HISTORIC AND DESIGN REVIEW COMMISSION

HDRC CASE NO: 2016-488
ADDRESS: 215 CLAUDIA ST
LEGAL DESCRIPTION: NCB 2876 BLK 1 LOT 7
ZONING: RM-4,H
CITY COUNCIL DIST.: 1
DISTRICT: King William Historic District
APPLICANT: Ricardo McCullough
OWNER: Vidal Gonzalez
REQUEST:

The applicant is requesting a Certificate of Appropriateness for approval to:

1. Construct a single story addition to the rear of the primary historic structure.
2. Construct a two story apartment at the rear of the lot.

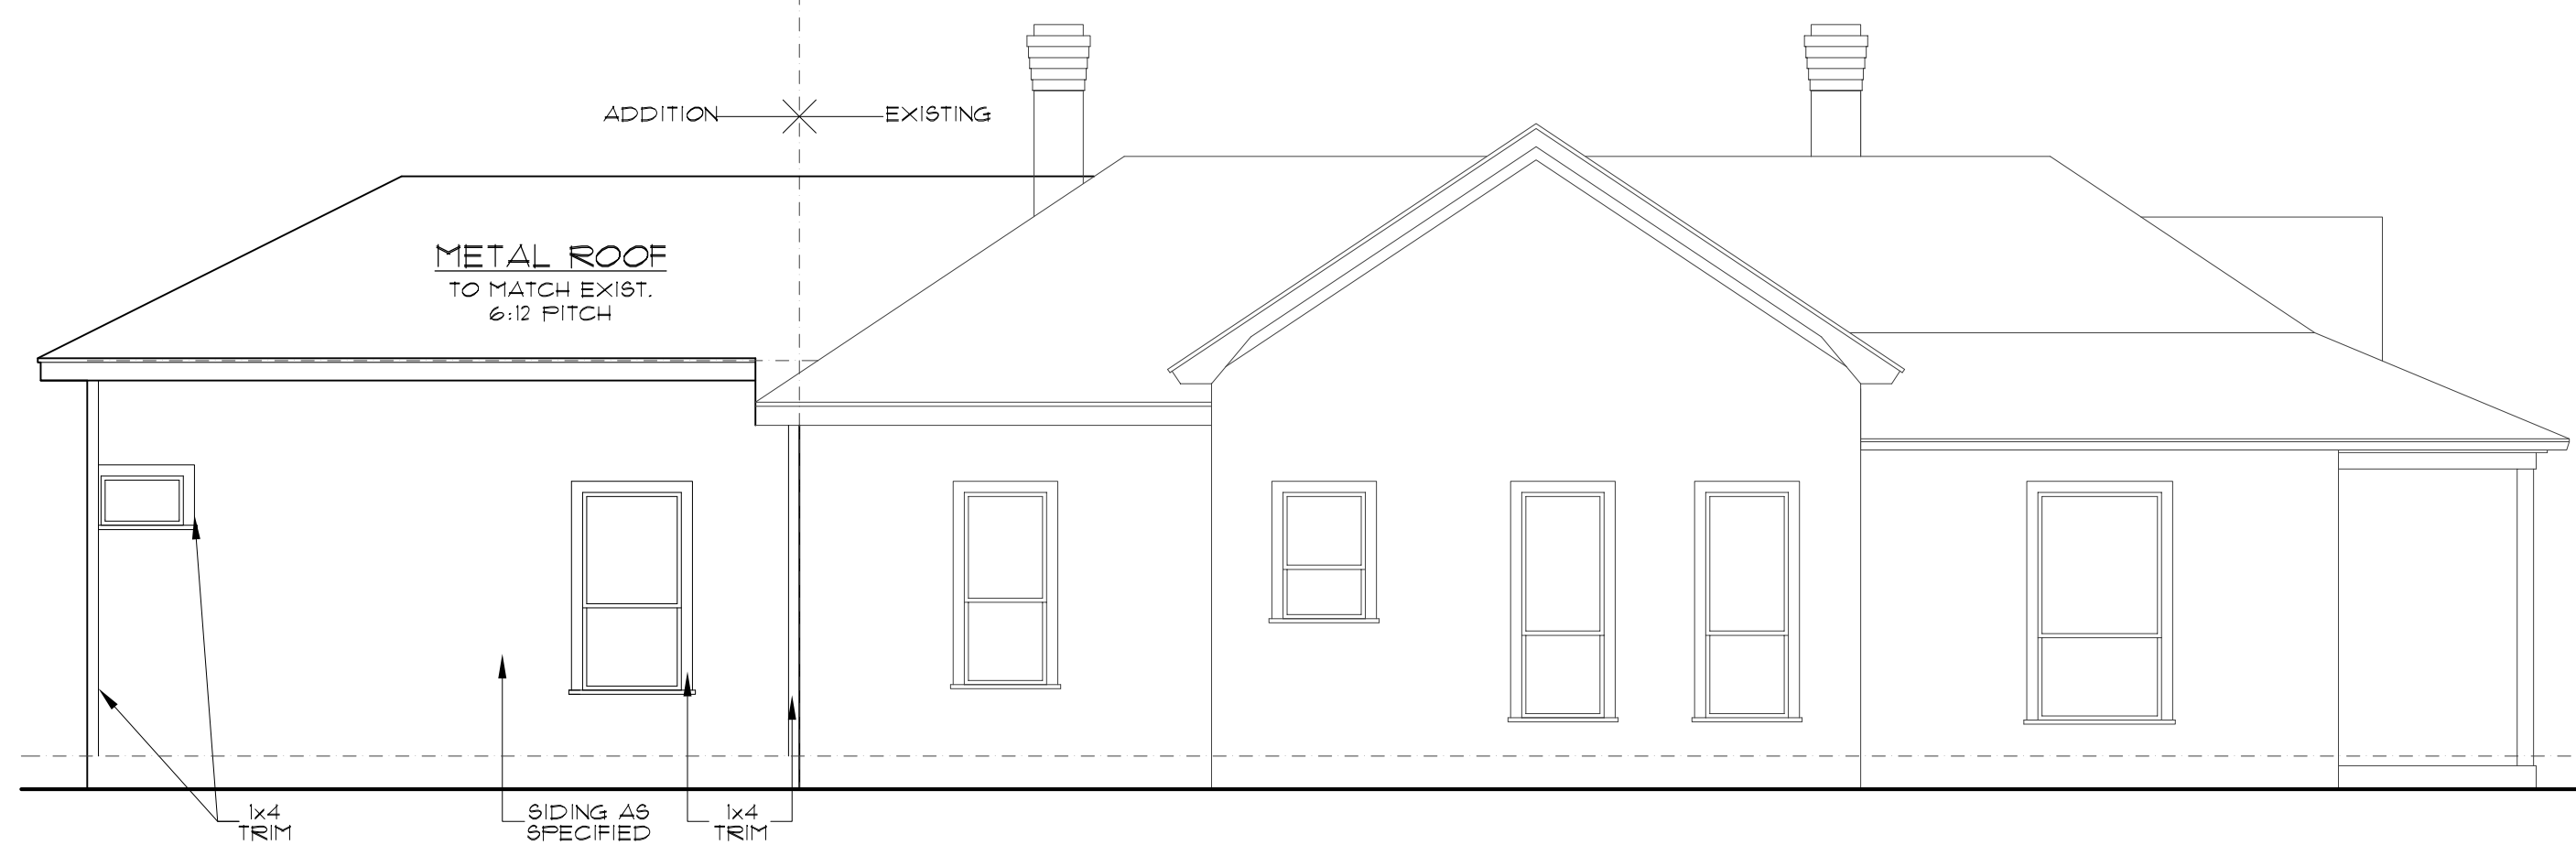
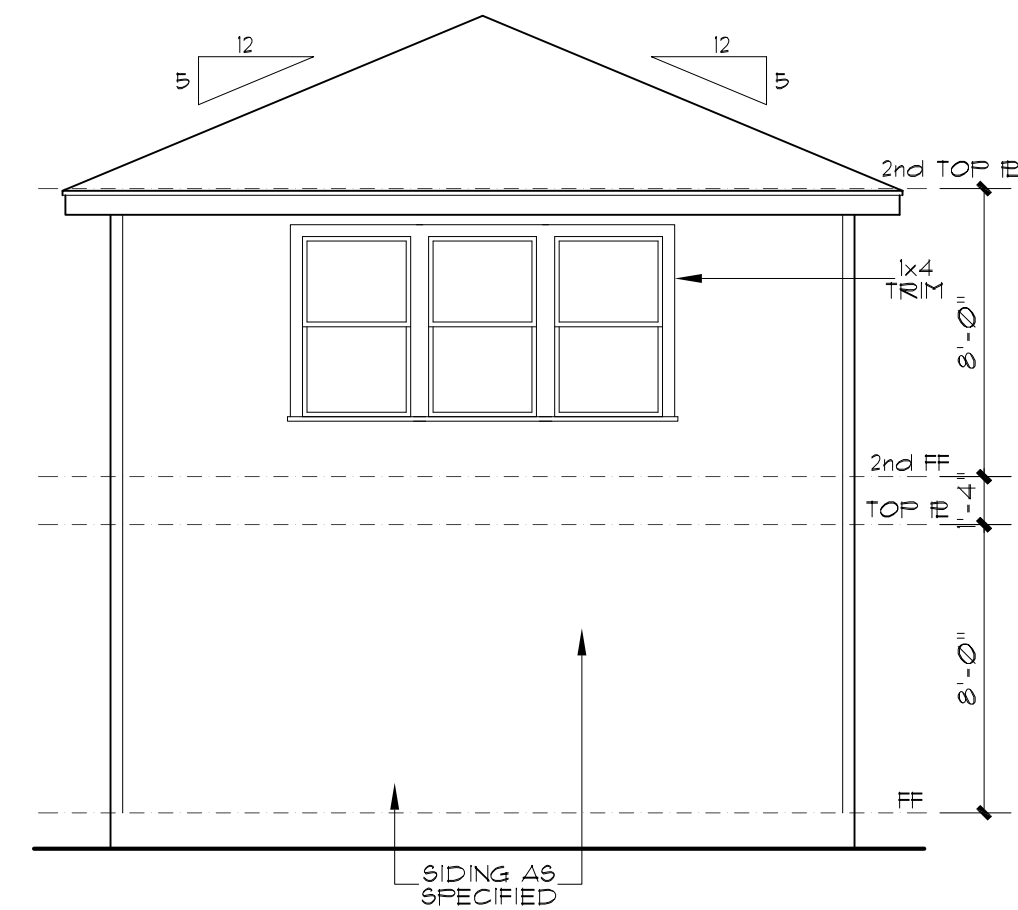
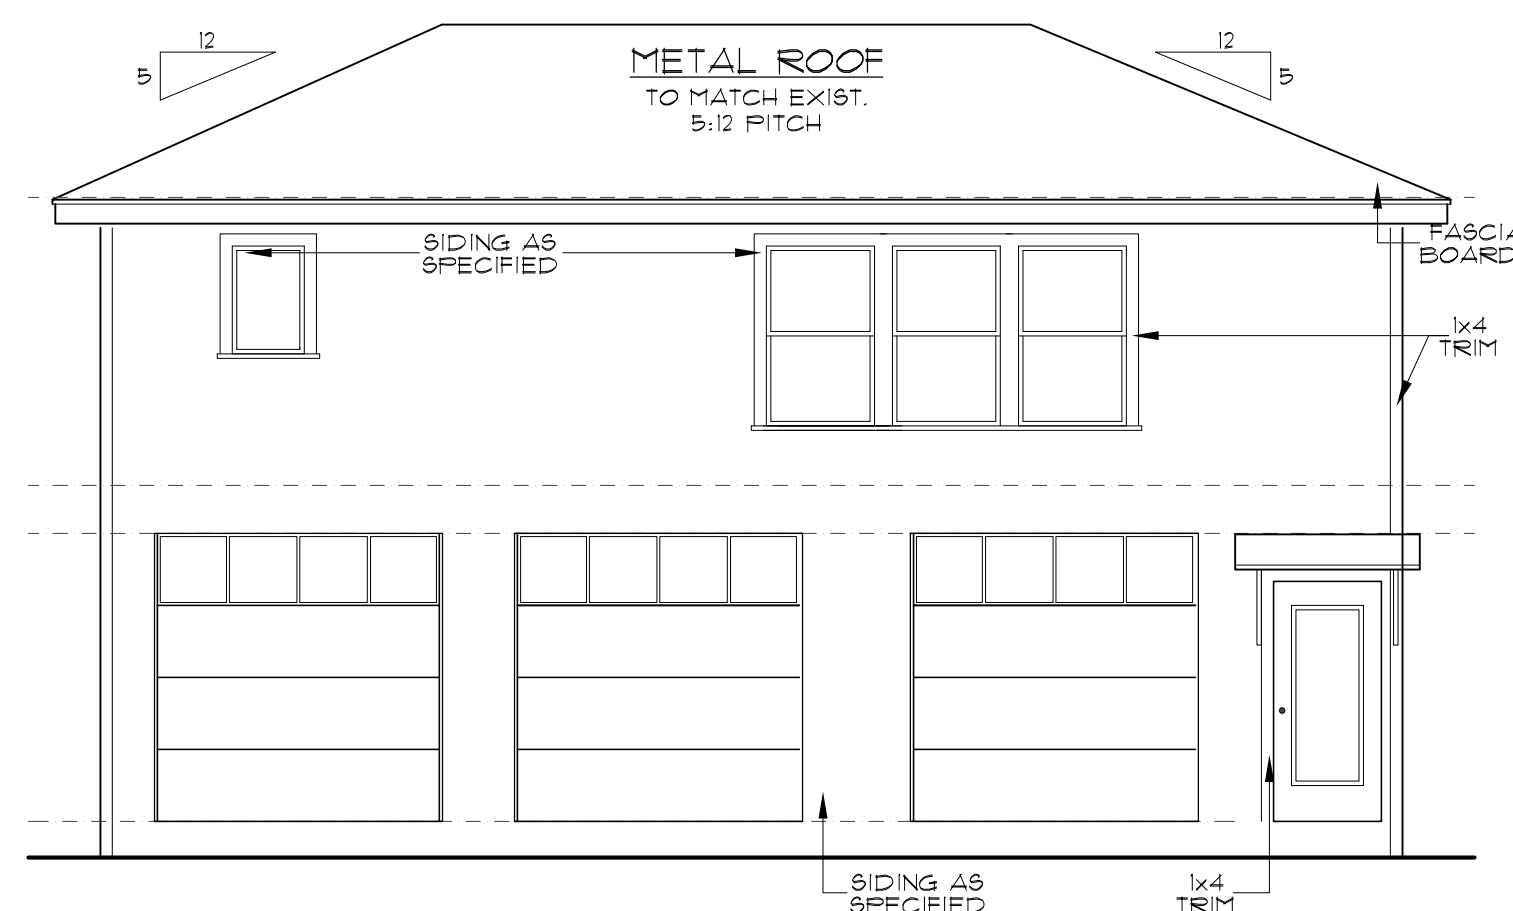
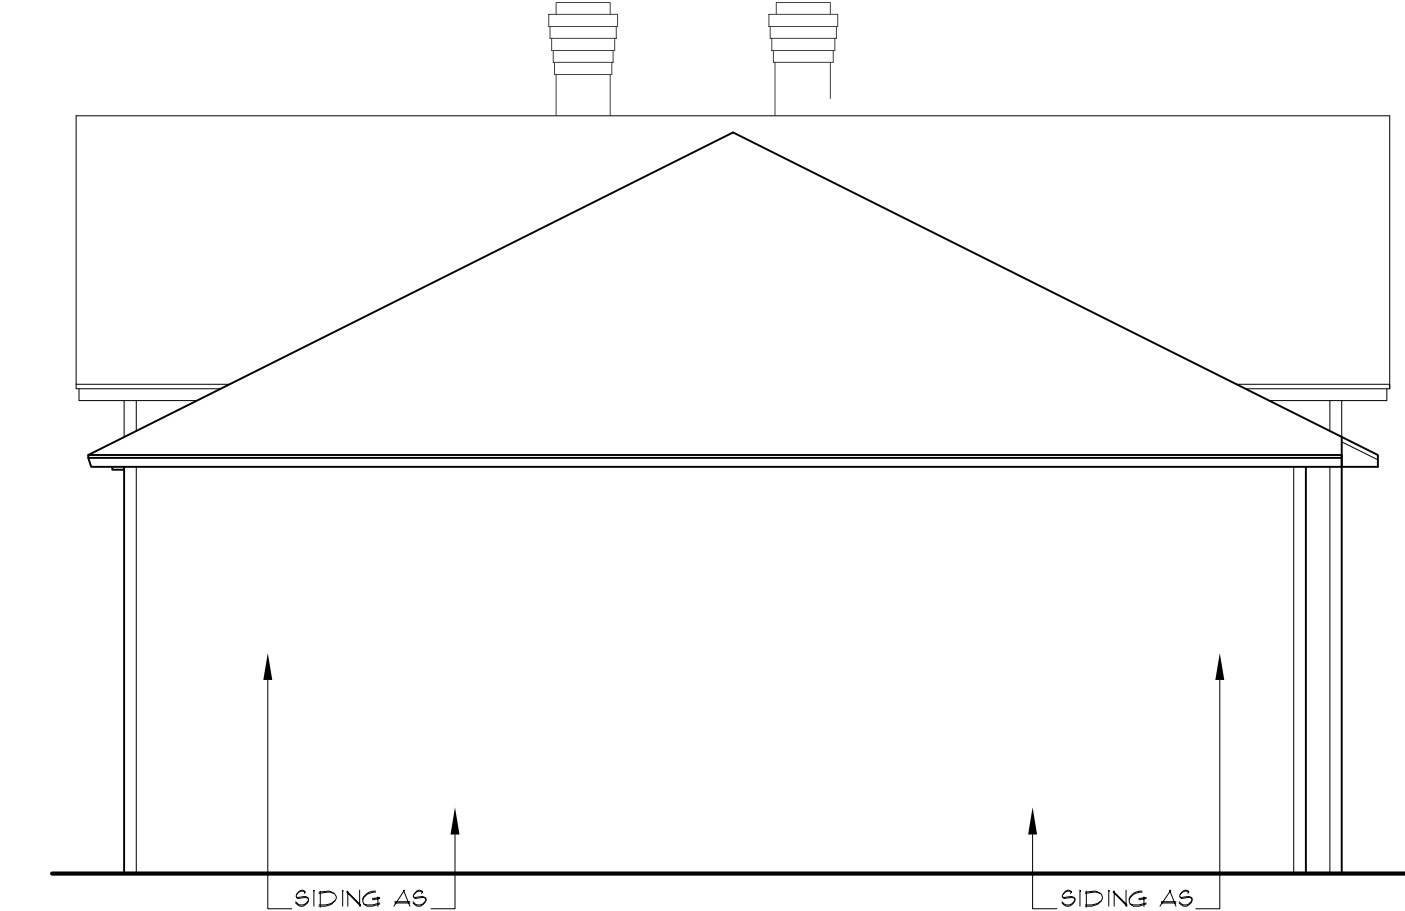
- f. **ADDITION FENESTRATION** – The applicant has provided elevations of the proposed addition that generally features window openings that are comparable to those of the primary historic structure. The Guidelines for Additions 4.A.i. states that the shapes of window opening should relate to those of the primary historic structure. Staff finds that the applicant should propose additional fenestration on the rear façade of the proposed rear addition.

Staff recommends approval of items #1 and #2 based on findings a through g with the stipulation that the applicant include additional window fenestration on both the rear façade of the proposed rear addition and the ground floor of the proposed garage.
